Docket Item # 2
BAR CASE #2011-0246

BAR Meeting
October 5, 2011

ISSUE: Alterations (signage, awnings, air intake louver/air vent openings)

LOCATION: 277 S Washington Street

Figure 1: Existing east façade.

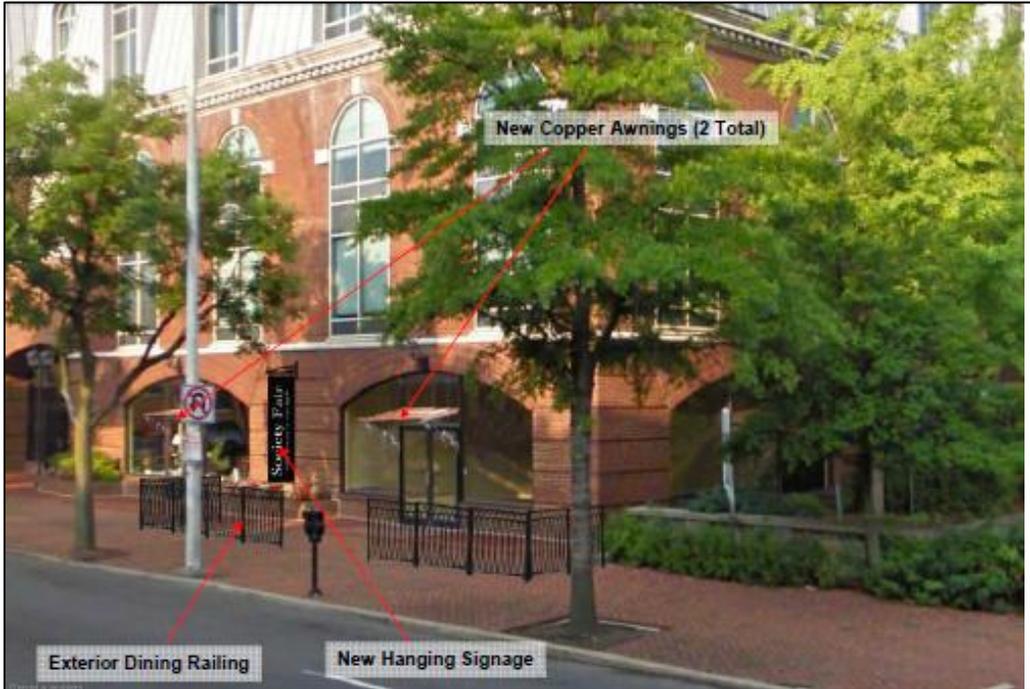
1. That the scroll bracket is installed in the mortar, and not the brick;
2. That the sign is reduced by 5 square feet, measuring approximately 2'-6" x 5'-0";
3. That the final design of the metal scroll in the transoms above the doors is approved by Staff;
4. That the new air intake louver and air vents are painted to match the adjacent wall surface.
